FILE P.I. No. 0008301, Taliaferro County
CSSTP-0008-00(301)
CR 82/Bethany Church Road over North Fork Ogeechee River
Bridge Replacement

SUBJECT APPROVED REVISED PROJECT CONCEPT REPORT

SUBJECT **REVISED CONCEPT REPORT**

REVISED PROJECT CONCEPT REPORT

DRAWING No. 5-1

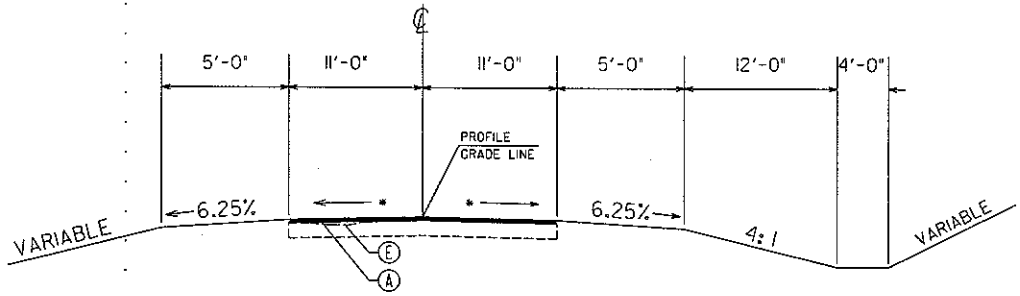
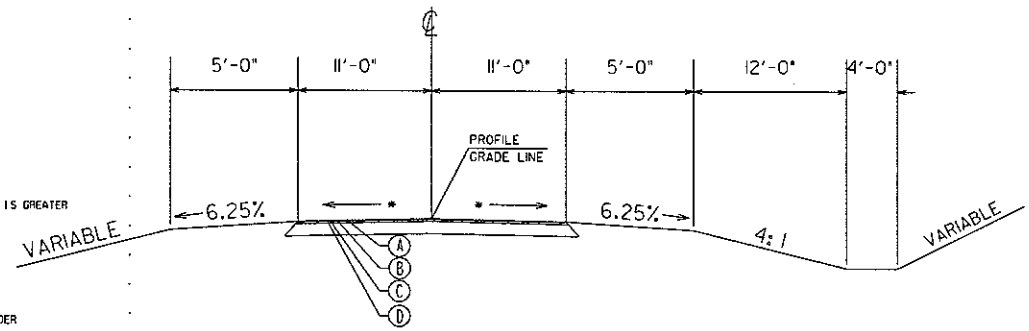
Lane Width: This office is requesting to revise the project lane width from 2 12-ft. lanes to 2 11-ft. lanes to match the existing conditions and minimize the purchase of additional right of way. A Design Variance will be required.

Shoulder Width: This office also requests a change in the current approved shoulder width from 10-ft. grassed to 5-ft. grassed. The proposed 5-ft. grassed shoulders meet the Green Book standard for low volume roads and would allow the tie-ins to be closer to the existing right of way.
